U.S. DEPARTMENT OF ENERGY
CERTIFICATE OF COMPLIANCE
For Radioactive Materials Packages

1a. Certificate Number 9761	1b. Revision No. 2	1c. Package Identification No. USA/9761/BX DOE	1d. Page No. 1	1e. Total No. Pages. 6
--------------------------------	-----------------------	---	-------------------	---------------------------

(1) Model Number: CA-WN-901 Krypton Shipping Container

Safety Evaluation Report
Model No. CA-WN-901 Krypton
Shipping Container
Docket No. 87-15-9761

Figure 2.
Krypton Package in the Super Tiger

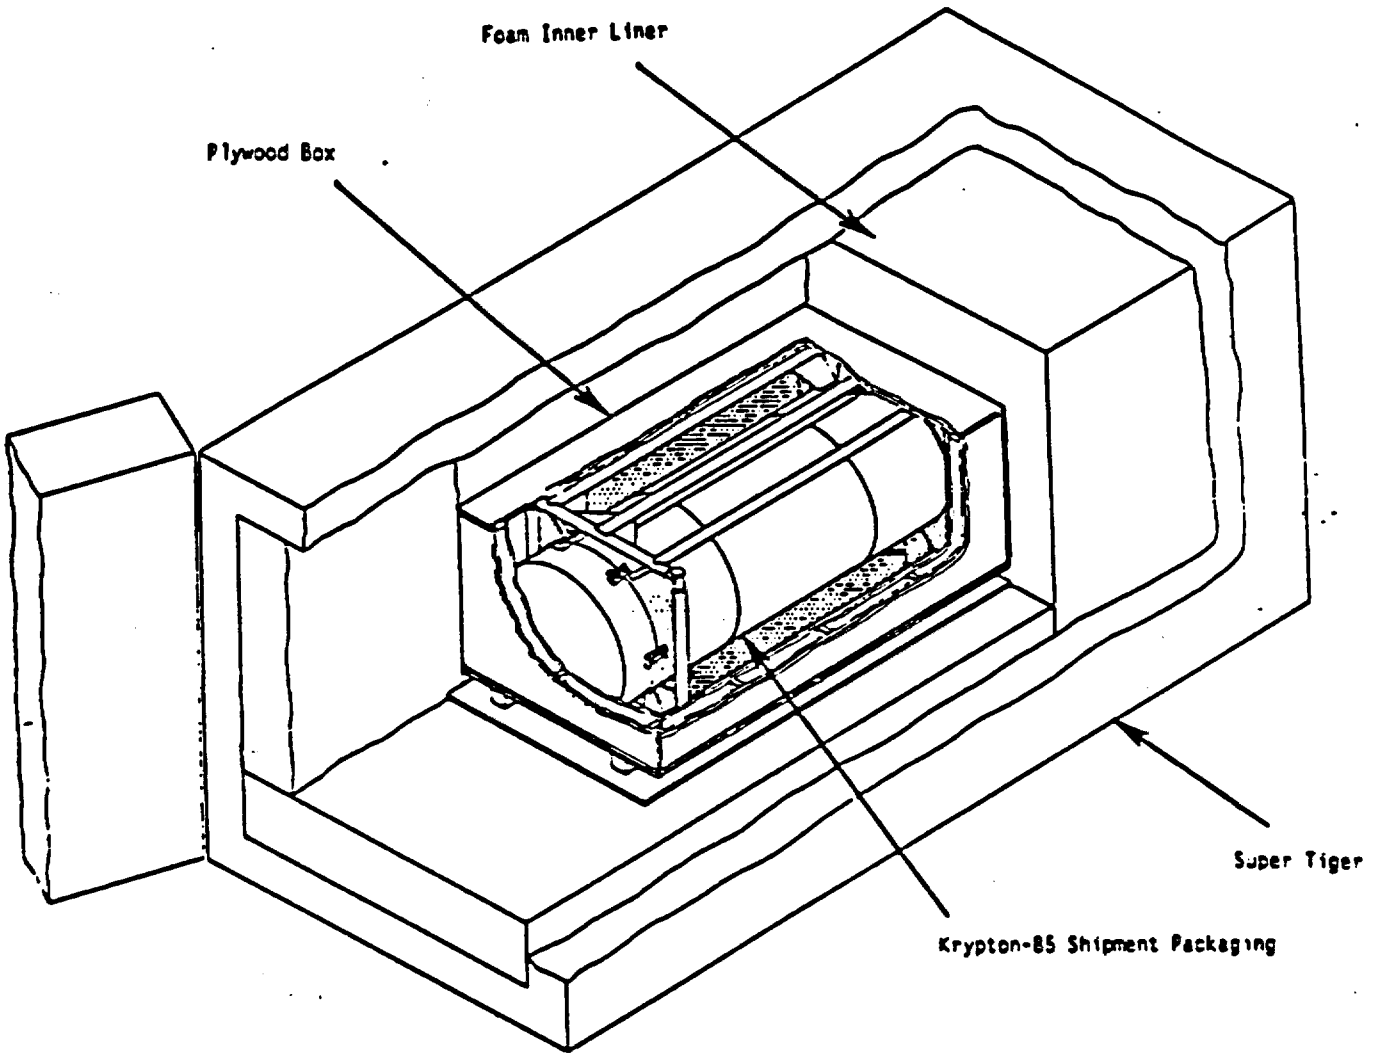
- a. The position and securement of the krypton package (See Figure 2) within the Super Tiger overpack, model number 6400, is as specified in drawing 059888, Westinghouse Idaho Nuclear Company, Inc. Report No. WIN-232, September 1987.

blocks of high density foam) is similar to one specifically approved in the Super Tiger certification.

The method of supporting the Krypton package in the Super Tiger Packaging has been reviewed to ascertain that the polyurethane blocks will be strong enough to transmit the loads that will be generated and that it will prevent any detrimental movement of the packaging during shipment. Protection against puncture of the krypton packaging is adequately provided for by the use of the Super Tiger.
